Progress Energy

Levy Nuclear Plant Units 1 & 2 Responses to RAI Comments on Cross Florida Barge Canal Recreational Access Permit

FDEP File Number
38-272432-002-ES

September 2008

STORMWATER/GRADING & EROSION CONTROL PLAN

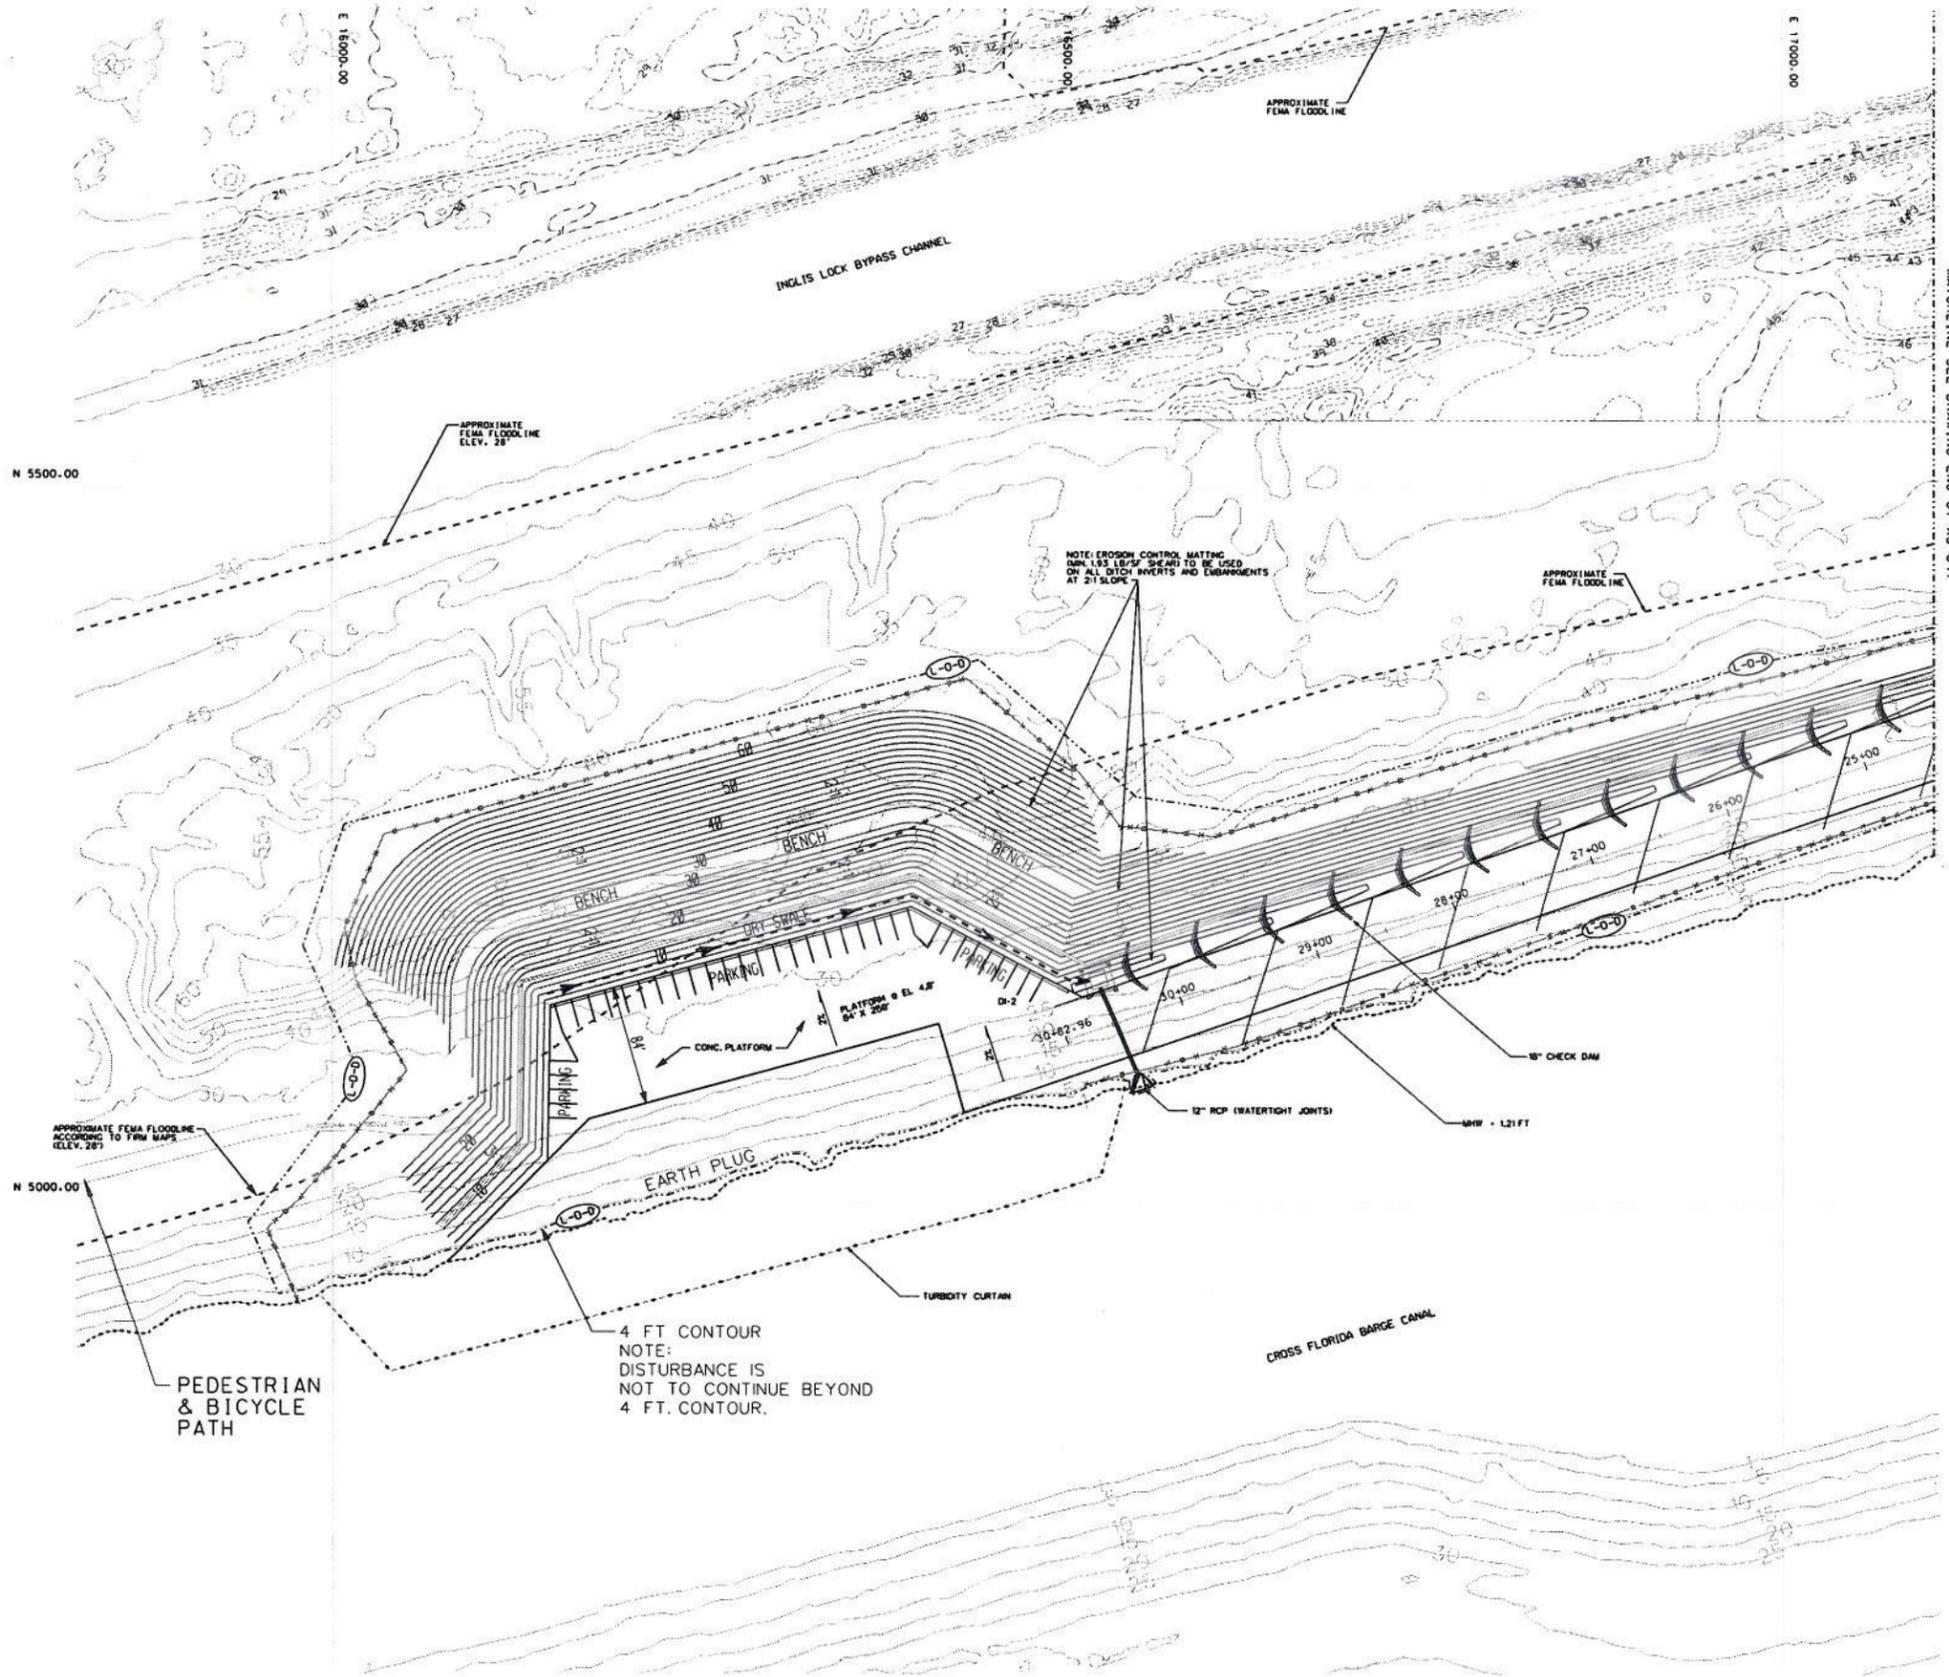
6. Are there pipes and/or culverts (existing or proposed) that are submerged or partially submerged, accessible to manatees during any tidal phase, and larger than 8 inches in diameter but smaller than 8 foot in diameter on the site?

6. There are no existing pipes to the Cross Florida Barge Canal. A single stormwater drainage pipe is proposed that will discharge from stormwater swales designed for this project. The pipe is labeled as “12” RCP (Watertight Joints)” in Drawing LNG-G1-XS-048, Stormwater/Grading & Erosion Control Plan, which is attached. The proposed pipe is a 12-inch diameter pipe with an inlet on the upstream (north) side and a mitered end section on the downstream (south) side at the Cross Florida Barge Canal. This pipe will be equipped with a 4-inch square grating to prevent manatees from entering and becoming trapped in the pipe.
